Access Compliance Report Public Rights-of-Way (Curb Ramps)

Main Street: ESENCIA_DR		Cross Street: FAUNA_DR		Location:	N
ADA ID: RPRK211201123903	Ramp Type:Type 1 - Perpendicular	Initial Pass/Fail: Fail	Overall Compliance: No	Severity Score:	2

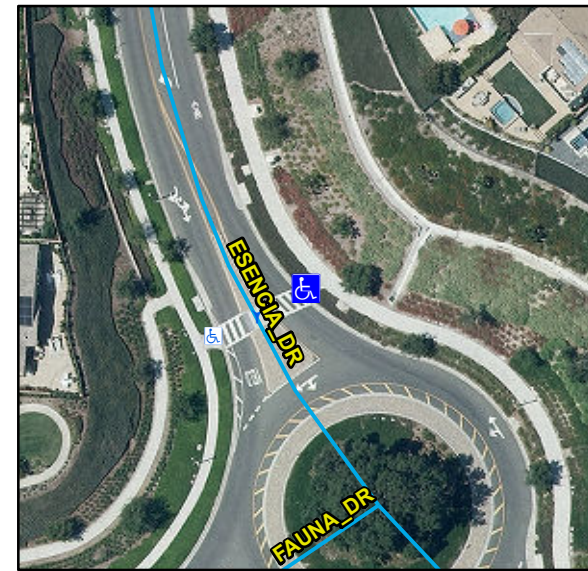
R304.2.2, R304.5.3, STD 1115

Remove & Replace Entire Ramp.
